Town of Gorham Planning Board Meeting October 4, 2021

ITEM 3 – Site Plan Amendment: Grondin Aggregates, LLC – Brandy Brook Quarry – a request for site plan review and approval of a winter salt storage shed and stump and brush processing at 57 Ossipee Trail. Zoned Rural (R), Suburban Residential (SR), Urban Residential (UR), Map 42, Lot 5. The applicant is Larry Grondin and he is representing himself.

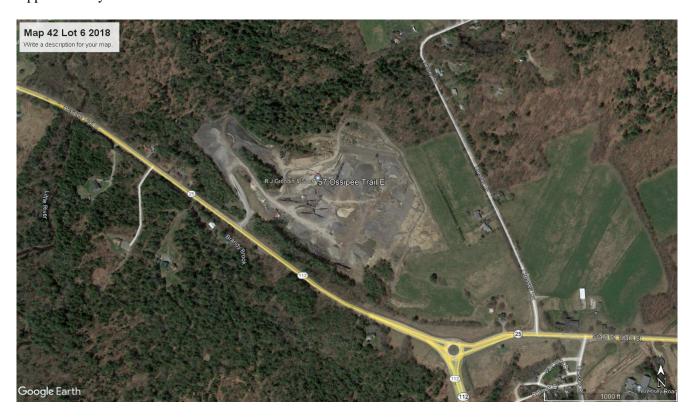
- <u>C.</u> Staff has included an aerial photographs for the Planning Board's review of the project. The aerial photograph is from Google Earth and is a series since the 1998 approved plan. There have been at least three amendments since that original blasting permit approval. They are:

- 1998 to allow blasting; 10 acre open quarry at any one time; required each phase be reviewed and approved prior to next phase beginning; clean fill only

- March 2002 to add truck scales & scale house
 - July 2002 to reduce the buffer in the northwest corner
 - April 2004 to allow 36 blasts and abutter notification change
